Colonial Durham Associates | Mill Plaza

Landscaping along Mill Road

Reference: <u>December 1, 2021 updated site plans</u>

Excerpt from left side of Sheet L2.1 (rotated)

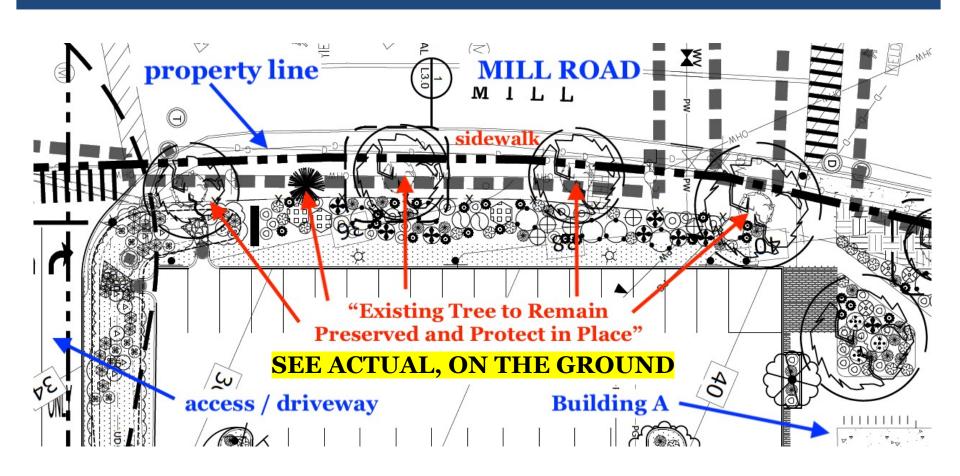
- Colonial Durham owns the strip along Mill Road between the parking lot and the Town-owned sidewalk; it is not a right-of-way.
- Landscaping plans show "existing trees to remain," plus deciduous shrubs and many perennials.

- The shrubs will provide required screening. The perennials may present a maintenance challenge and lose aesthetic appeal quickly.
- Existing trees include a stump and at least 1 tree of questionable health.

- Shouldn't this area be improved with trees to match the quality proposed for the rest of the 10-acre site?
- Plans also show an "ornamental wood fence" just inside the property line, represented by a thin solid line marked periodically with an X (see later slide).

- We have not seen any details or rendering for that fence. It is not shown on the view from Mill Road on "<u>Site Plan Perspectives 1-2-20</u>." (That rendering also does not represent what is shown on the December 1, 2021 plans.)

Permit Drawings April 3, 2020 Sheets Loo.1 through Loo.4

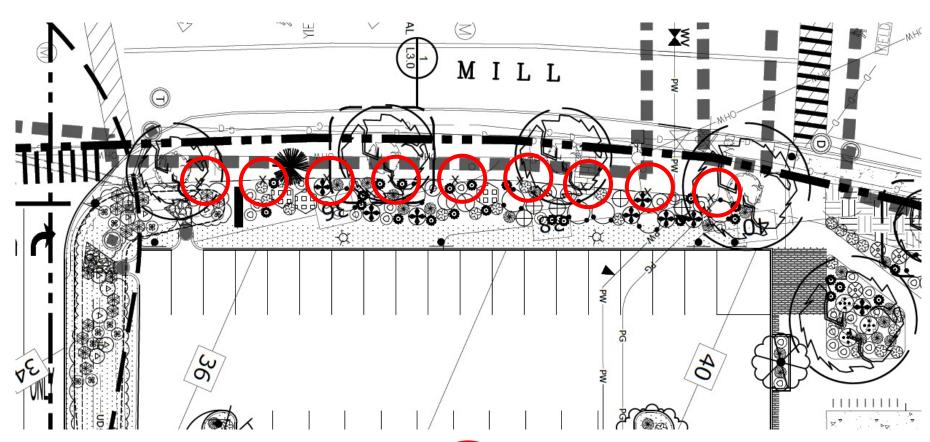
"Ornamental Wood Fence" shown just inside property line

fence = thin solid line with

but not identified
